**FINDINGS AND RECOMMENDATION
OFFICE OF PLANNING AND ZONING
ANNE ARUNDEL COUNTY, MARYLAND**

CASE NUMBER: 2025-0184-V

The applicants are requesting a variance to allow a dwelling addition (two-story deck with stairs) with less setbacks and buffer than required and with disturbance to slopes of 15% or greater on property located at 348 Hunner Road in Pasadena.

PROPOSED LOWER DECK PLAN
SCALE: 1/4" = 1'-0"

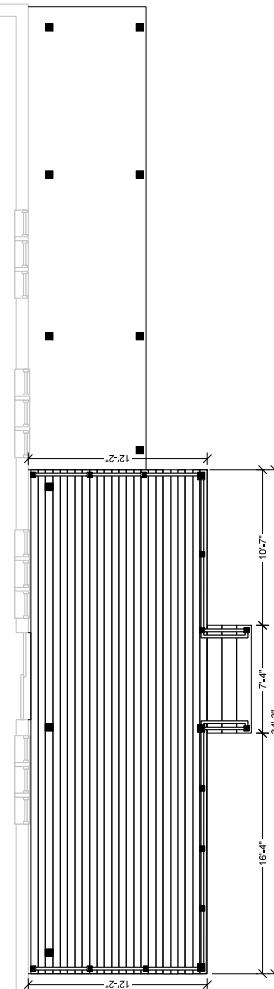
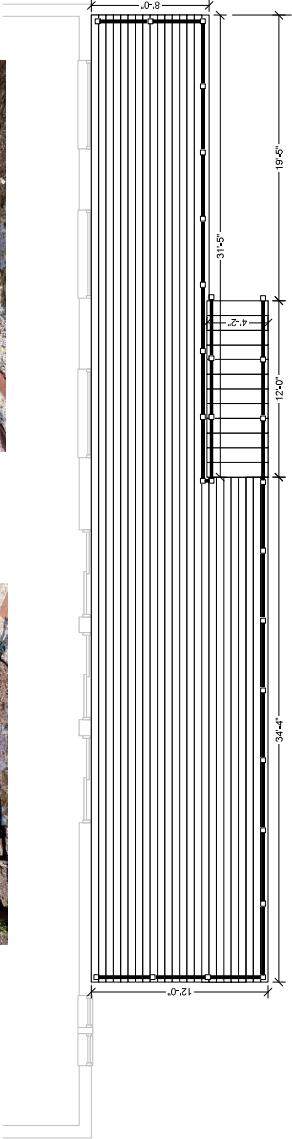
The **Zoning Administration Section** notes that the current proposal appears to exceed the area of the existing deck being removed. In order to allow for proper review, the applicant should submit an existing conditions site plan and a proposed conditions site plan, and both levels of deck should be shown on the site plan with dimensions for each level. The site plan should also be updated to show the slopes of 15% or greater, the buffer, and the limit of disturbance (LOD) required for access during construction. The property already has the luxury of extensive decking that far exceeds that which is typical of most waterfront lots in sloped areas. Any expansion of the existing deck would not be supported. In fact, redevelopment allows the opportunity for minimization and to improve upon the existing conditions. The applicant is advised that, in order for the proposed Critical Area variances to be approved, the applicant must demonstrate and the Hearing Officer must find that the proposal complies with each and every one of the Critical Area variance standards provided under Section 18-16-305(b) and (c), including demonstrating that the variances are the minimum necessary to afford relief. Therefore, the variance letter of explanation should be revised to specifically address each standard.
